Access Compliance Report

Public Rights-of-Way

(Curb Ramps)

Intersection ID: 10016341	Main Street: UNIVERSITY_CITY_BV	Cross Street: N/A	Location: SE
ADA ID: B85713DBE36F	Ramp Type: Directional1	Initial Pass/Fail: Pass	Overall Compliance: No
			Severity Score: 2.5

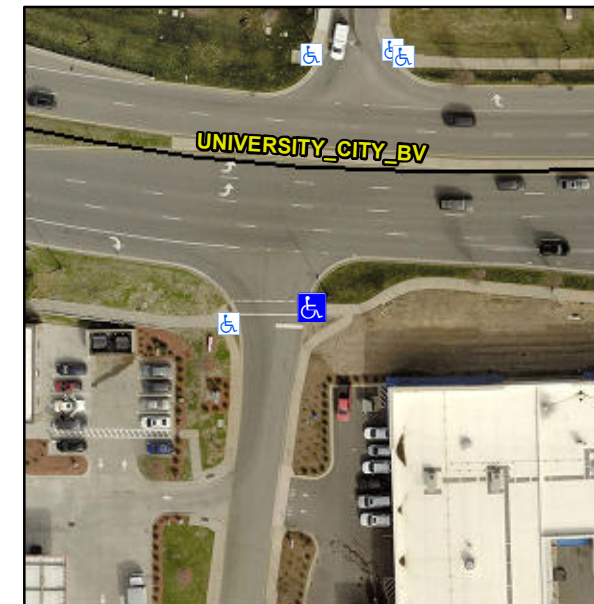
R305.1.4

Remove & Replace Detectable Warning System.
